8-10 New McLean Street

Proponent Response Proposal

Prepared for
DPHI

Issued
July 12 2024

Visual Impact

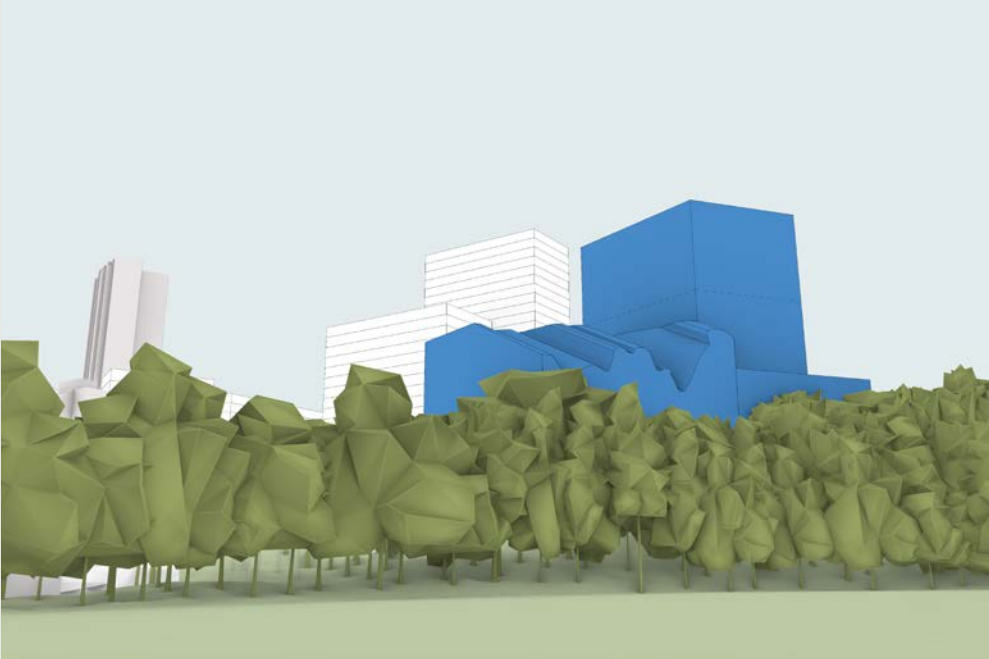
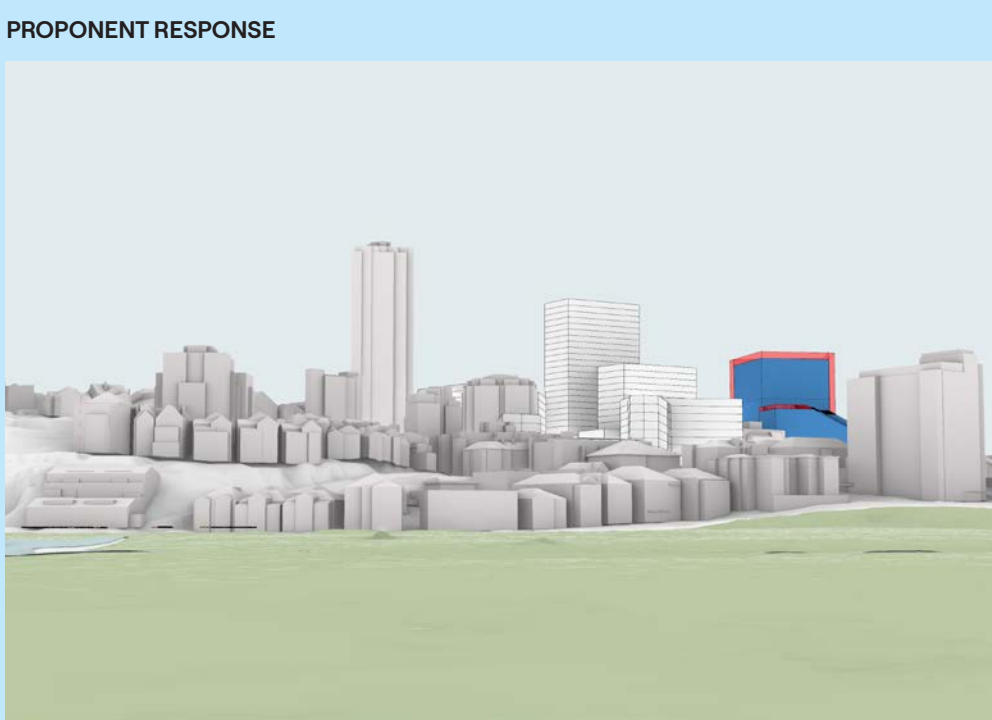
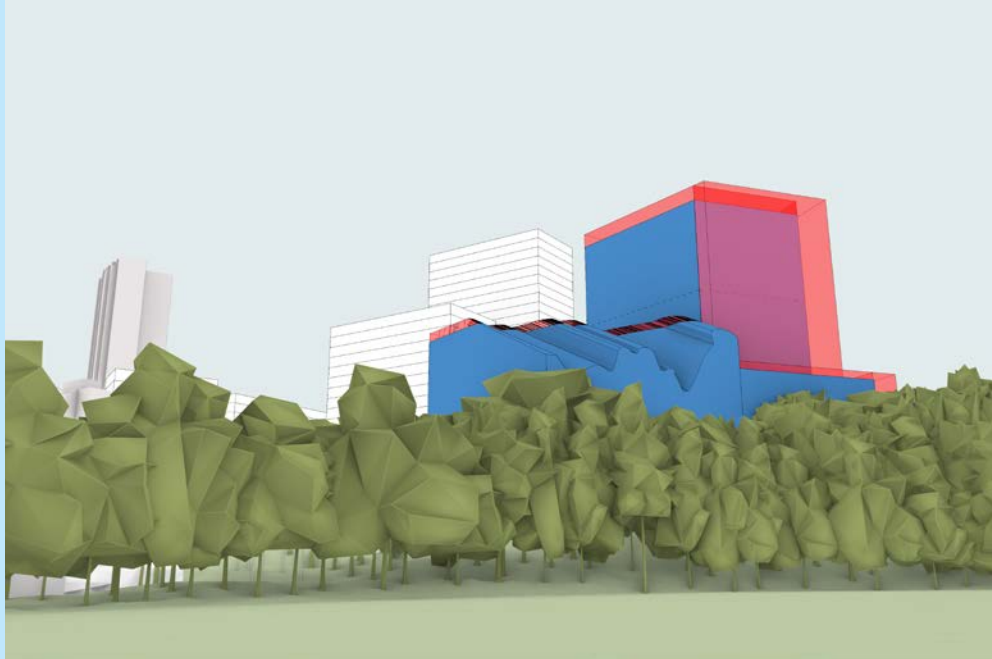
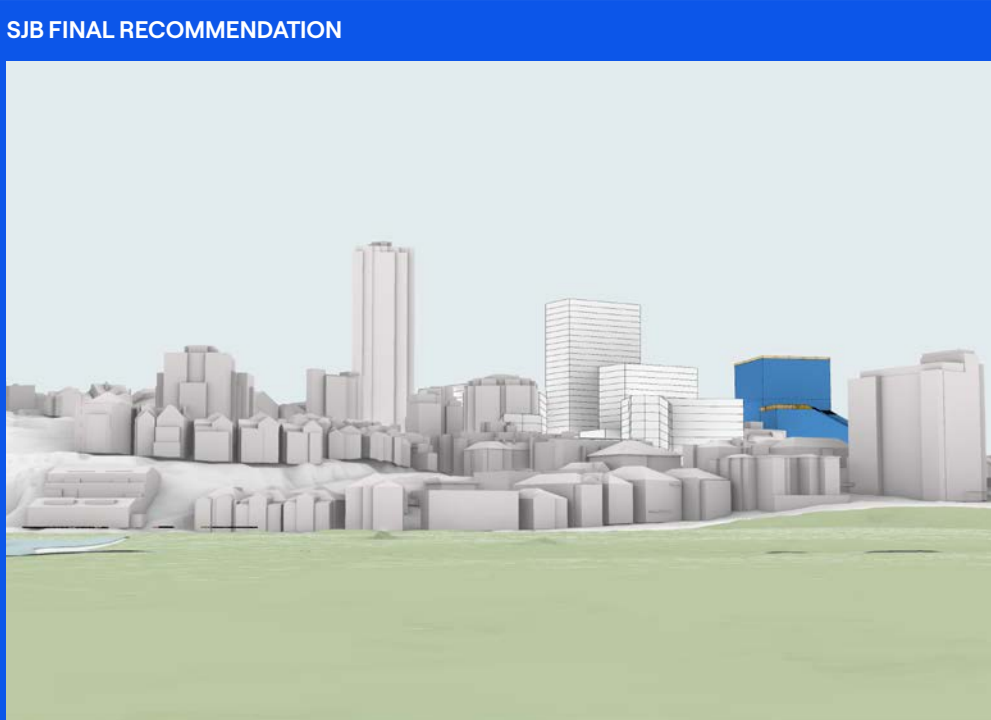
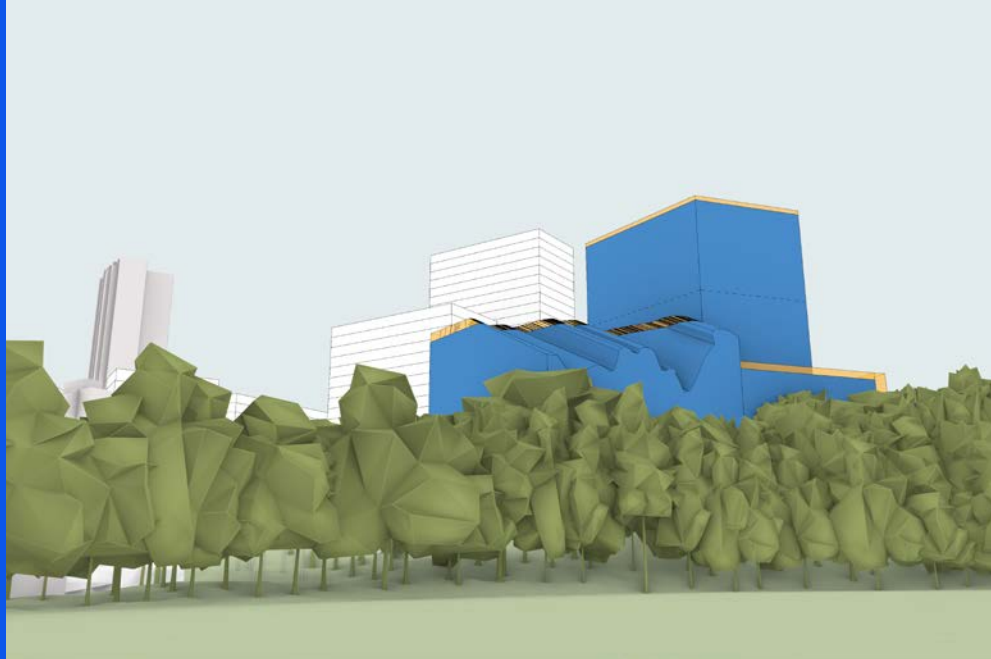
In maintaining the current tower envelope, the visual impacts are significantly reduced. Views from Rushcutters Bay Park maintain an appropriate transition between the ECC massing and surrounding areas with a similar effect taking place when viewed from Trumper Park. By maintaining the initial tower footprint the reduction in visual impact from the southern corner of the tower envelope is evident from this view.

Visual Impact

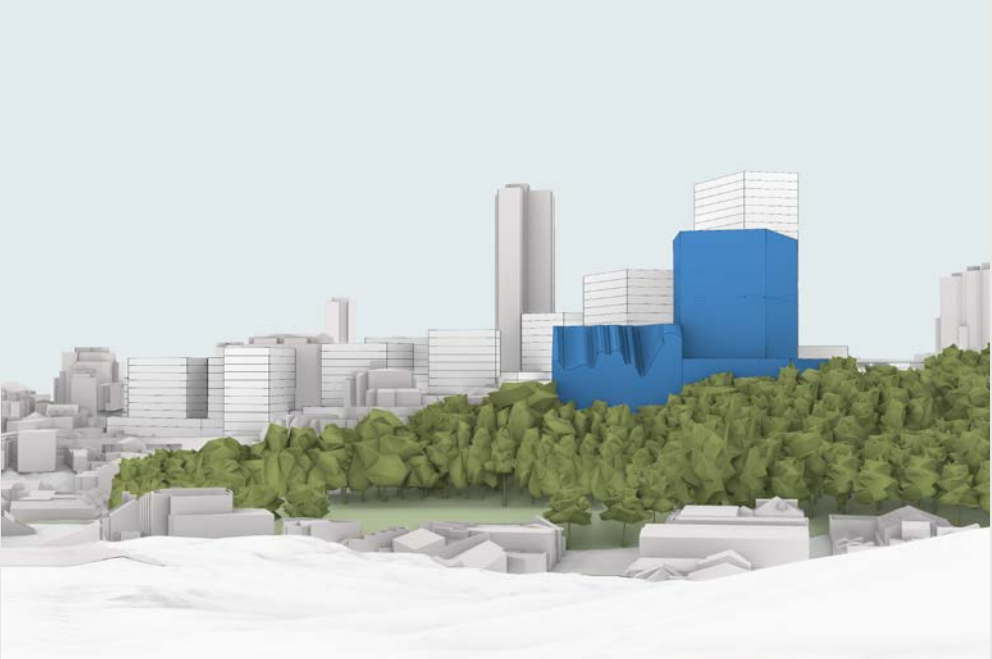
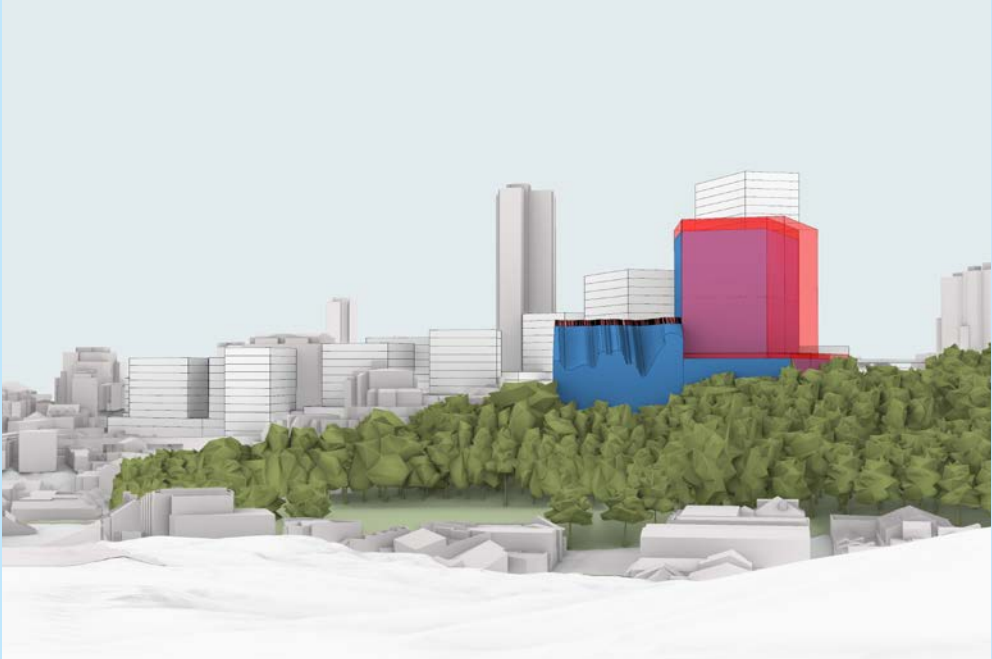
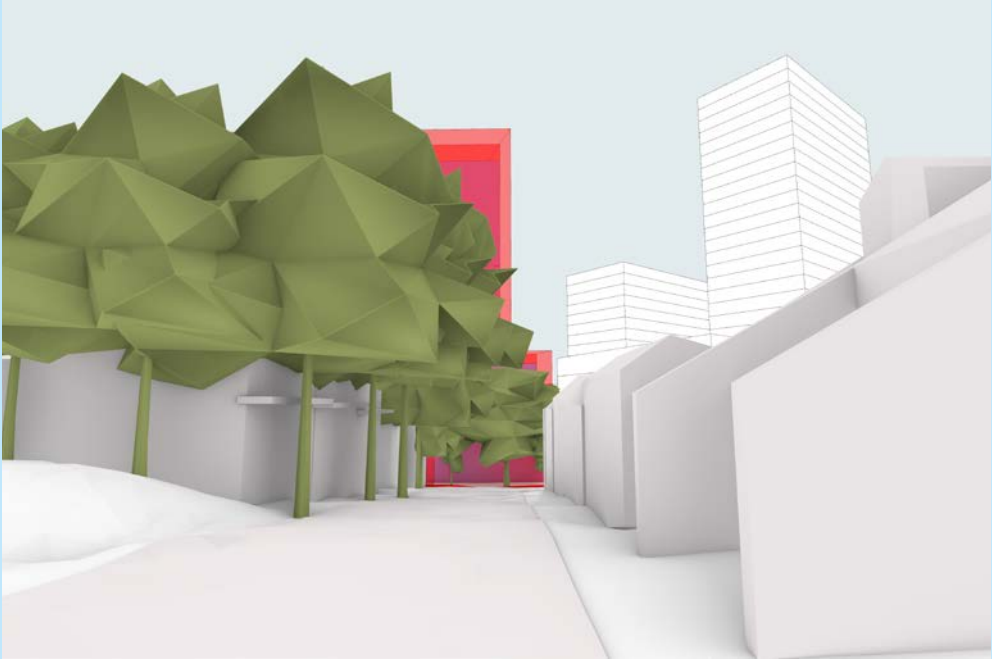
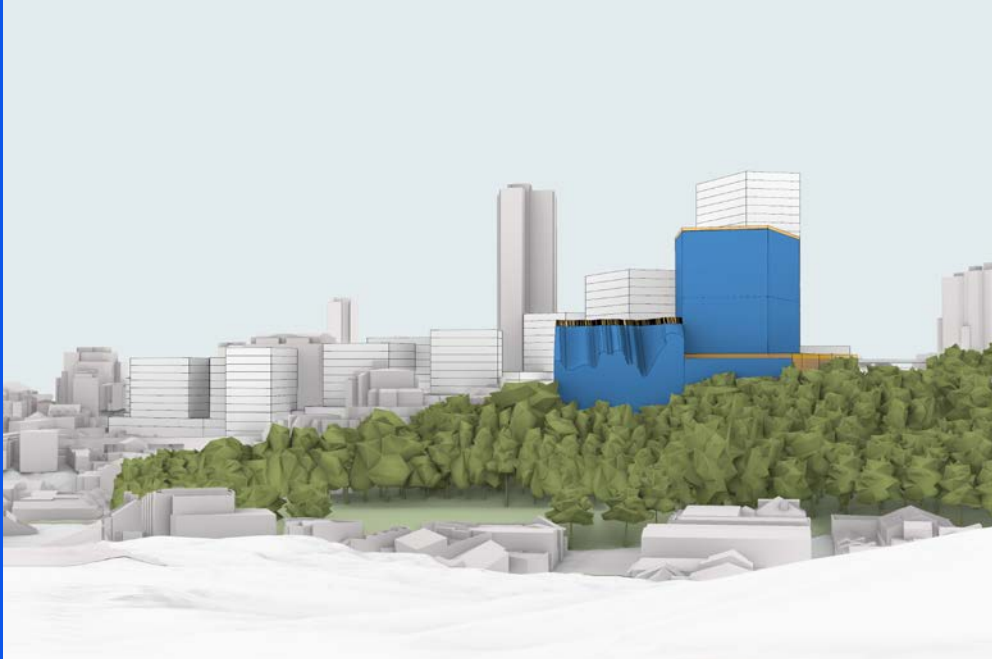
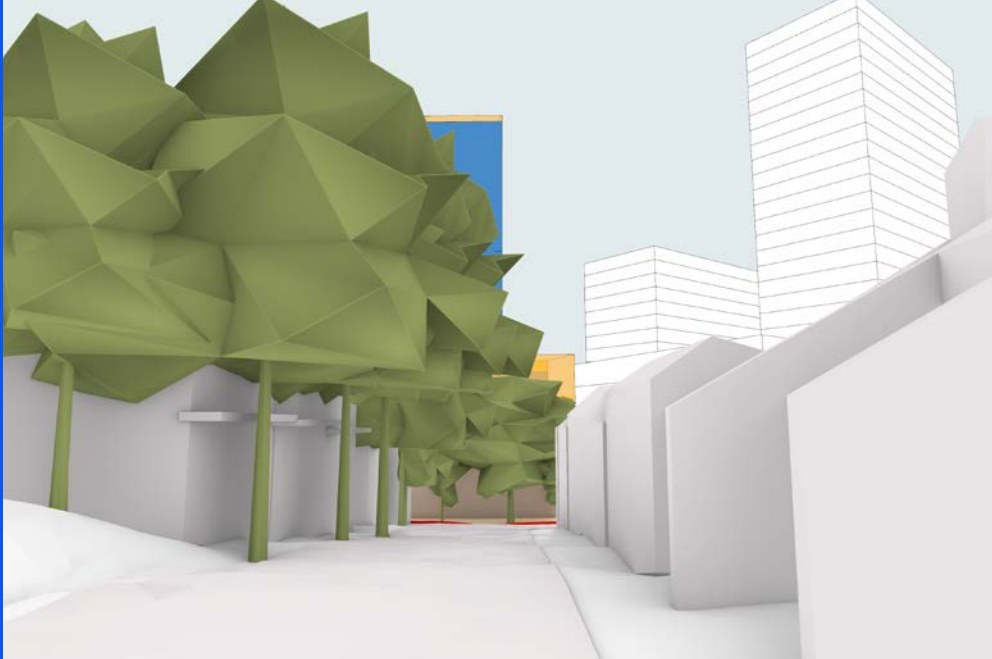
Views from Cascade Street demonstrate that the proposed largely sits within the ECC silhouette, whilst still providing appropriate visual hierarchy to the ECC massing.

From Cameron Street, situated between the terraces to the south-east of the site, the impact to views is similarly reduced, with extensions to the podium remaining largely obscured.

SJB Envelope Testing

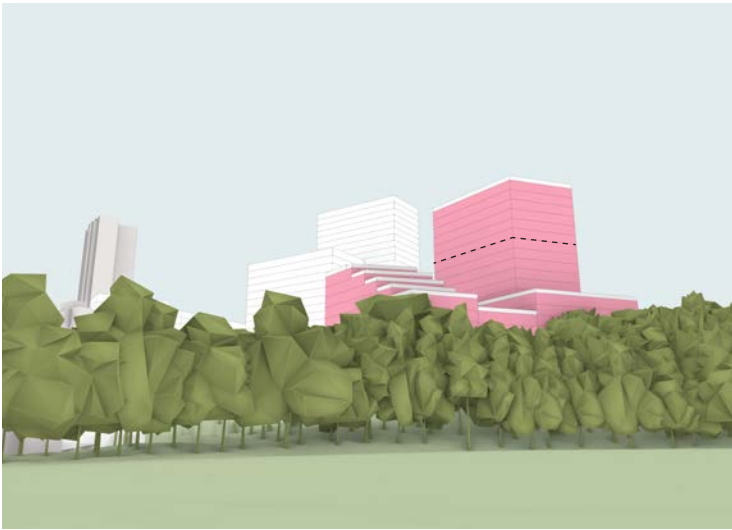
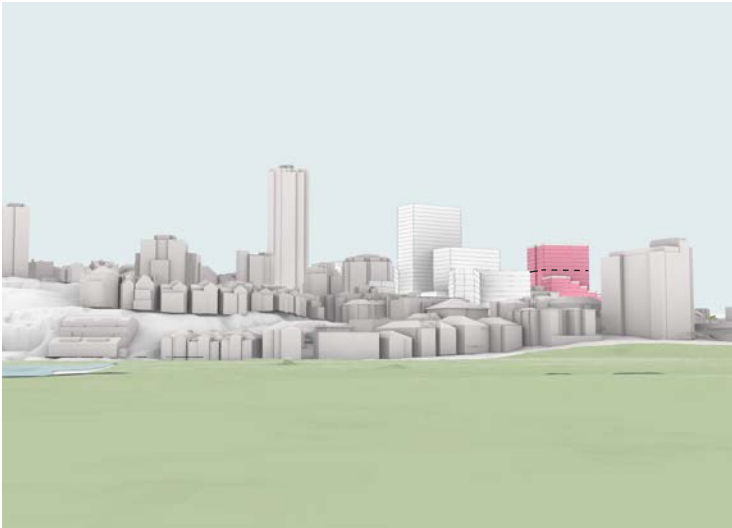
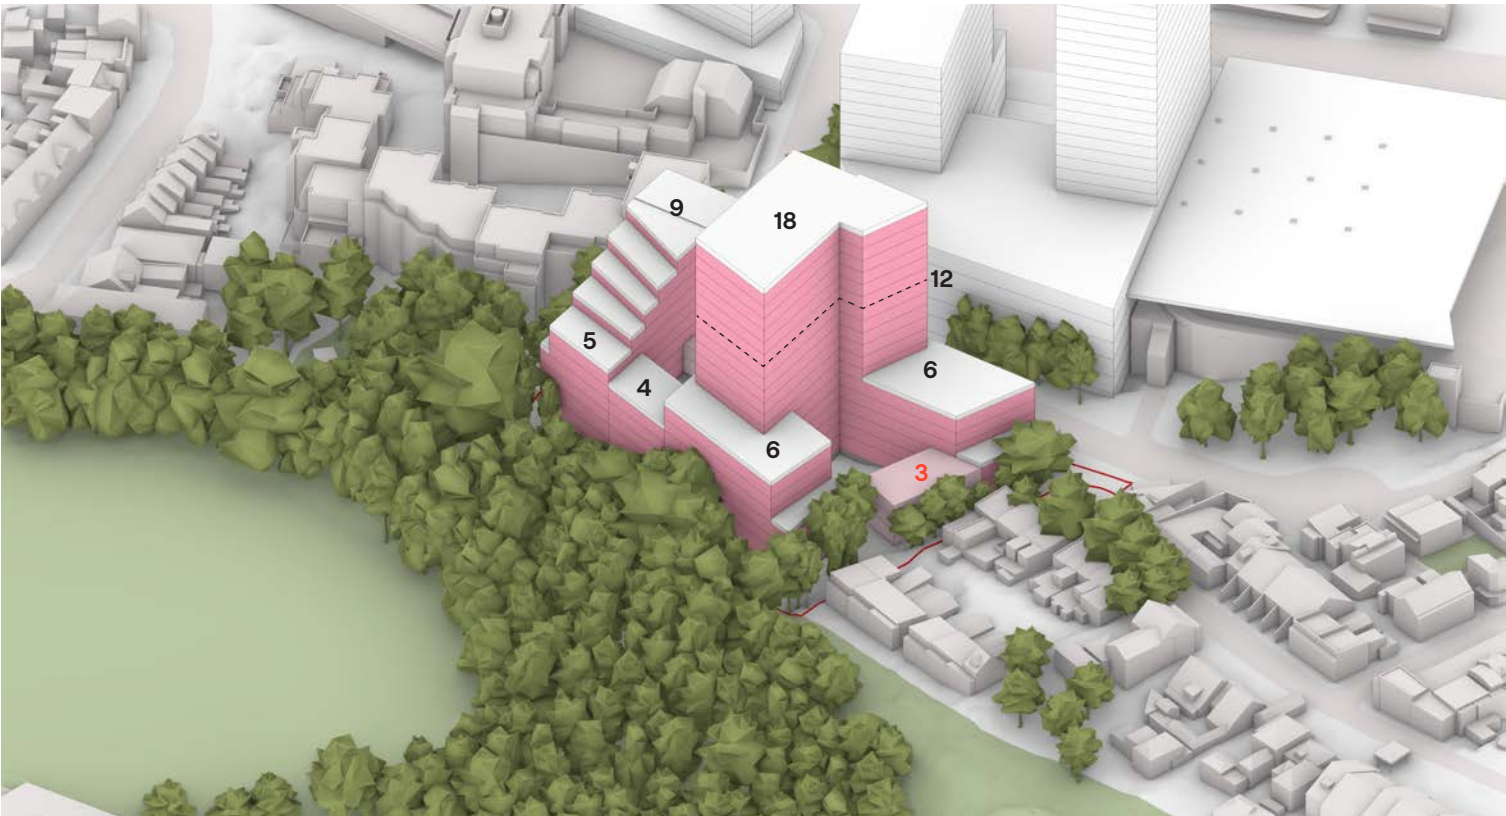
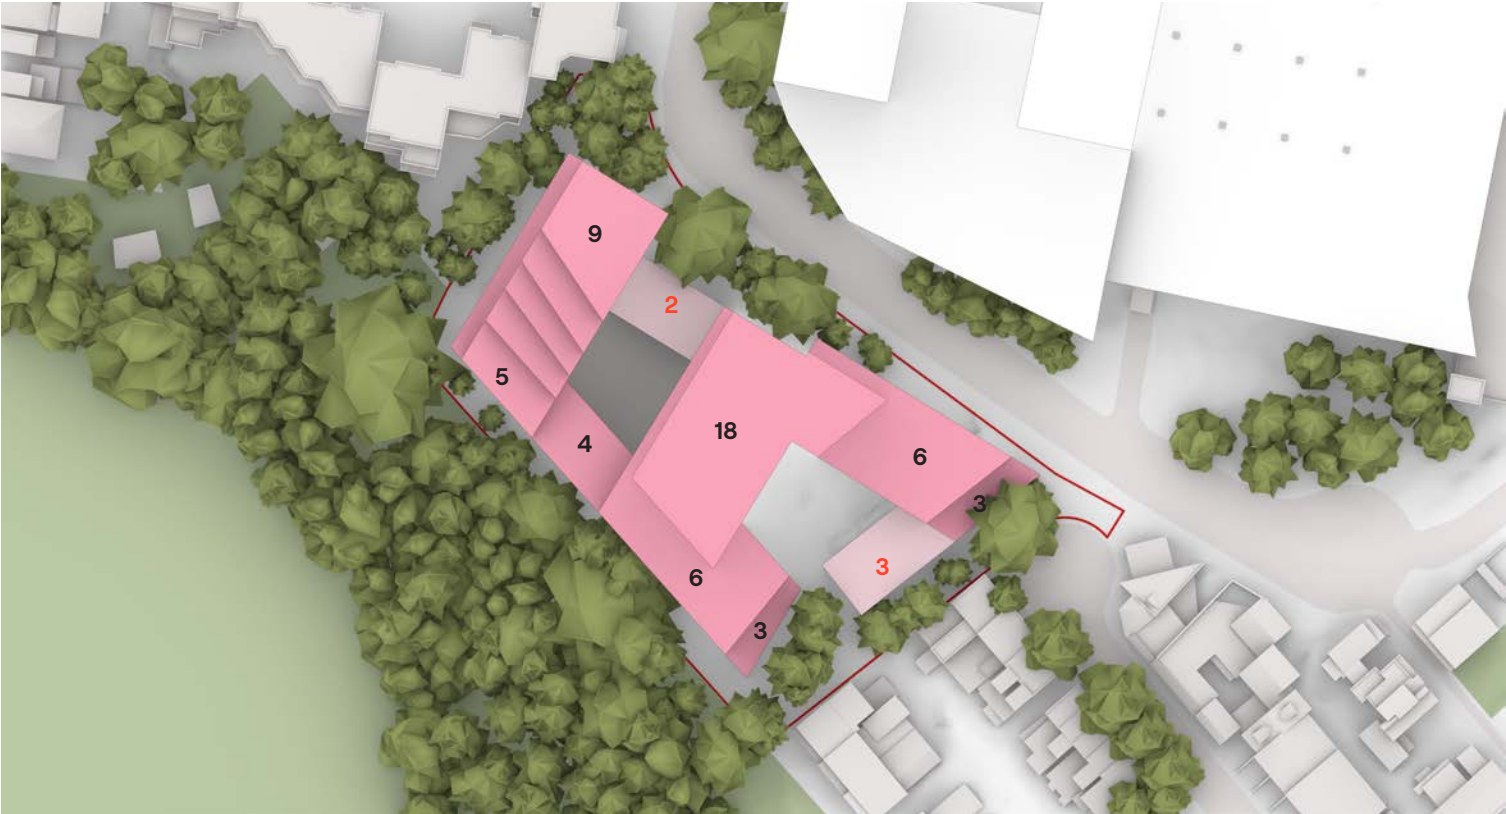
Following adjustment of the building envelope, an additional massing approach has been tested to ensure the resultant built form would still be appropriate within the proposed final envelope.

The footprints of the southern massing have been extended to fit within the final envelope, and the tower extended to create a 1,000m² GBA footprint. The resultant built form is 18 storeys and 3.6:1.

- A street wall height of 6 storeys, which is 1 lower than the proposed Edgecliff Centre, establishing an appropriate relationship in height,
- Transition to the HCA by stepping down to 3 storeys, aligning with the adjacent terrace.
- Significant tree retention through the proposed articulation and setbacks to side boundaries, including those along the eastern interface.

There is potential to increase the total FSR with more aggressive massing within the envelope (subject to ADG, residential mix and considerations of established principles). This has also been shown here in lighter pink and red text. These elements would allow the FSR to increase to 3.7:1 without significant impacts to residential amenity or to surrounding areas. However, appropriate consideration should be given to how the development is read from the street frontage, by minimising street wall length.
